# Access Compliance Report

## Public Rights-of-Way

| Intersection ID: 10577 | Main Street: JORDAN_PL | Cross Street: N/A       | Location: E            |
| ADA ID: 878B7927F5F5   | Ramp Type: Perp        | Initial Pass/Fail: Fail | Overall Compliance: No |

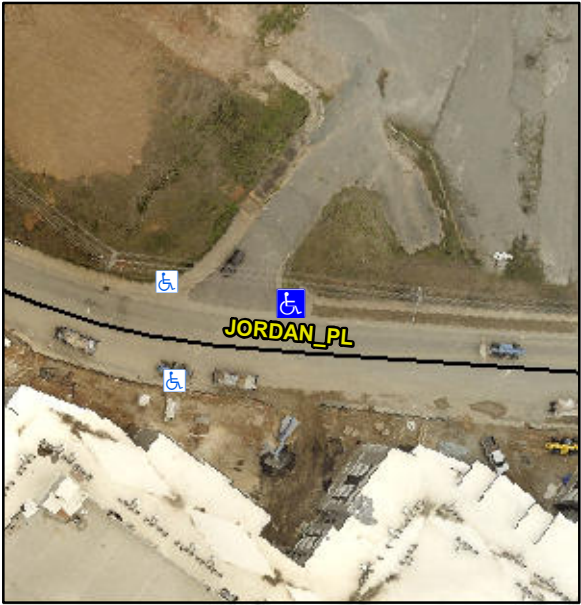
| Codes/Mitigation Info/Possible Solution                                          |                               | Field Measurements/Component Compliance |                       |       |            |                             |      |
|----------------------------------------------------------------------------------|-------------------------------|-----------------------------------------|-----------------------|-------|------------|-----------------------------|------|
|                                                                                  | Not Found, R304.5.1           |                                         |                       |       |            |                             |      |
|                                                                                  |                               | No                                      | Ramp Width (in)       | 30.5  | Yes        | Ramp XSlope (%)             | 4.5  |

| Codes/Mitigation Info/Possible Solution                                          |                               | Field Measurements/Component Compliance |                       |       |            |                             |      |
|----------------------------------------------------------------------------------|-------------------------------|-----------------------------------------|-----------------------|-------|------------|-----------------------------|------|
|                                                                                  | Remove & Replace Entire Ramp. |                                         |                       |       |            |                             |      |
